Printmount Switch LSG

**2 Type of Change:**

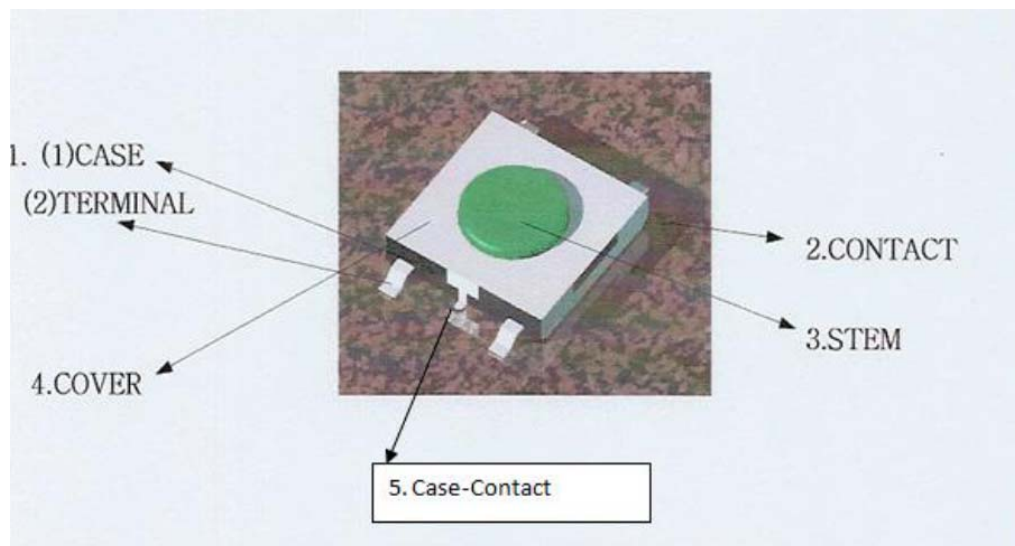
The case-contact will be removed.  
The part is listed with a new part number.

**Form and Fit:** The case-contact will be removed.

Technical Data	old	new
Soldering heat resistance:	250°C/ 20 s	230°C/ 45s
Initial contact resistance after lifetime:	max. 100 mΩ	max. 500 mΩ
End stop strength (withstand to an impact force):	50N/3 sec.	30N/3 sec.
Storage temperature:	-30°C to +85°C	-30°C to +80°C
Contact bounce:	typ 0.1 ms	< 10 ms
